Suggested Changes to NZS3101:2006 with Amendments 1 and 2

Richard Fenwick and Dene Cook

Figure 1: Recommended support detail for hollow-core floor units

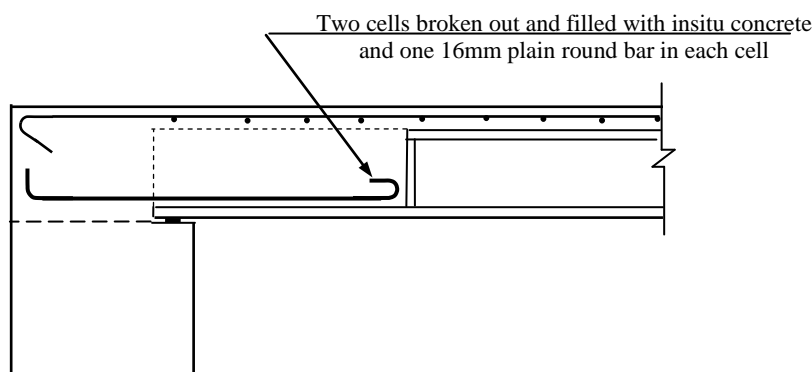
The DBH require an amendment to this clause, which is to add to the end of clause 18.7.4 (e) to following sentence.

“The details given by C19.6.7(e) may be applied to hollow-core units where the depth of the precast unit is equal to or less than 300mm”.

There is no clause or commentary clause 19.6.7 (e). However, there is a commentary clause C18.6.7(e), which is probably what was intended by the DBH. The intent of this modification is to prevent the detail described in this sub clause from being used where the depth of the hollow-core units exceeds 300mm. No rational explanation was given for this modification.

None of the above effects influence the flexural strength of reinforced concrete and consequently there appears to be no rational explanation of why the recommended support detail in C18.6.7(e) should be limited to hollow-core units with a depth equal to or less than 300mm. This modification by the DBH is likely to reduce the robustness of hollow-core floors built with hollow-core units with a depth greater than 300mm.
